Subject: GAP APPEARS IN HARD PLASTIC DOOR TRIM PANELS	Bulletin No: 09-006/07
	Last Issued: 2/15/2007

2006-2007 MX-5 with VINs JM1 NC**** ** 115173 to 127945 (built from March 1, 2006 to September 7, 2006)

1717a

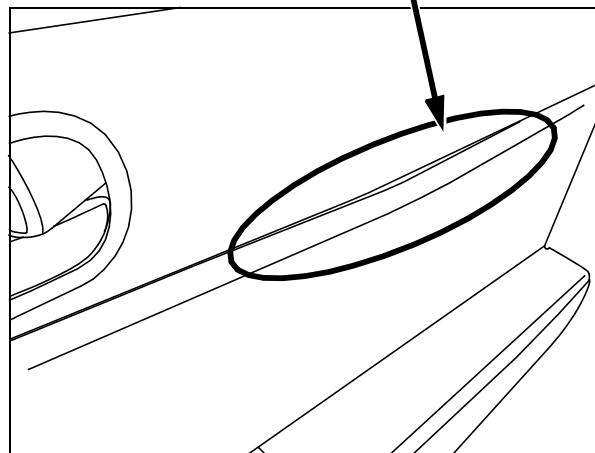
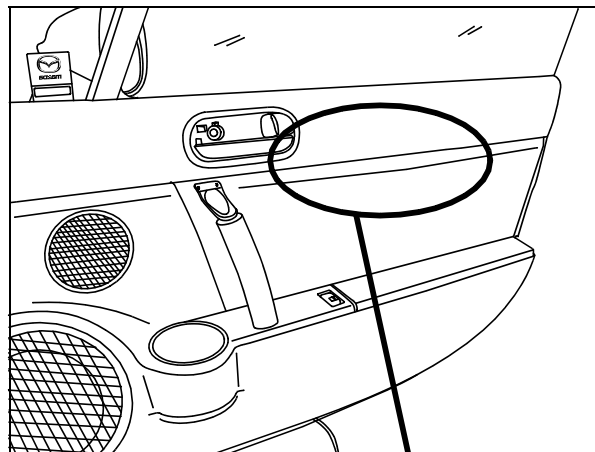
GAP IS NOTICEABLE BETWEEN UPPER
AND LOWER PORTIONS OF DOOR PANEL

During hot ambient temperatures, the foam pad attached to the door lock cable pushes the door panel out, causing a gap. As a mass-production change, the shape of the pad attached to the door lock cable has been modified.

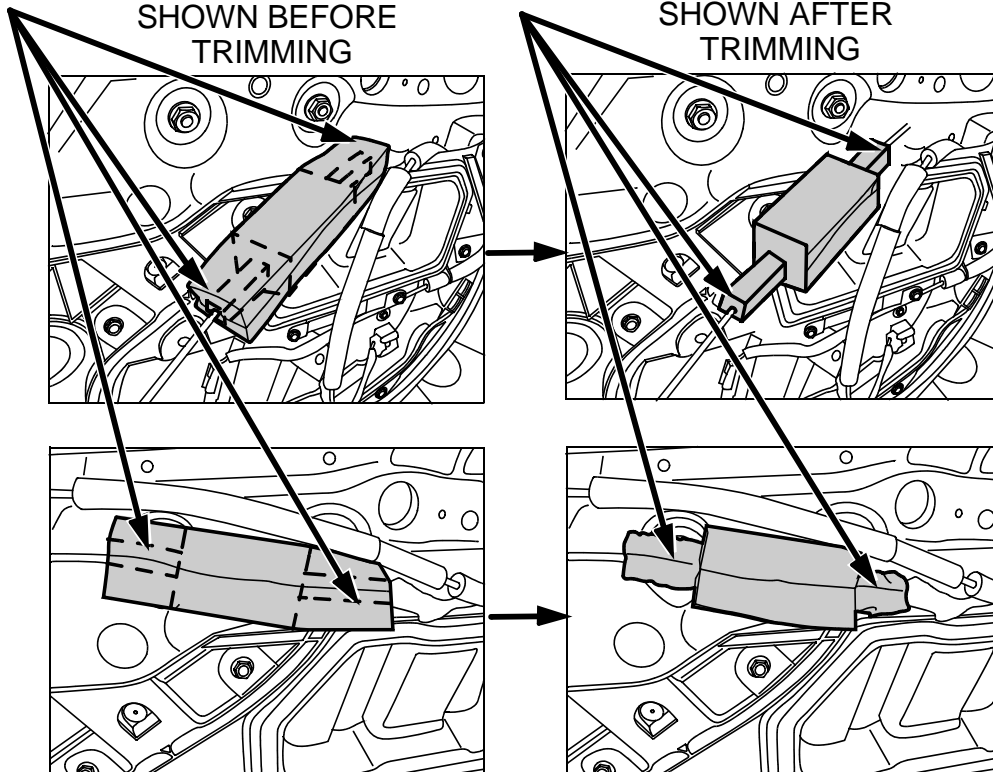
3. Trim the existing door lock cable foam pad as illustrated below.

- Trim foam approximately 1-1/2" (38mm) x 1/2" (13mm) inwards from each end until the finished product resembles the image below.

TRIM BOTH
ENDS OF
FOAM
INSULATION

FOAM PAD
SHOWN BEFORE
TRIMMING

LEAVE APPROX.
0.2" (5mm) OF
FOAM ON THE
CABLE

FOAM PAD
SHOWN AFTER
TRIMMING
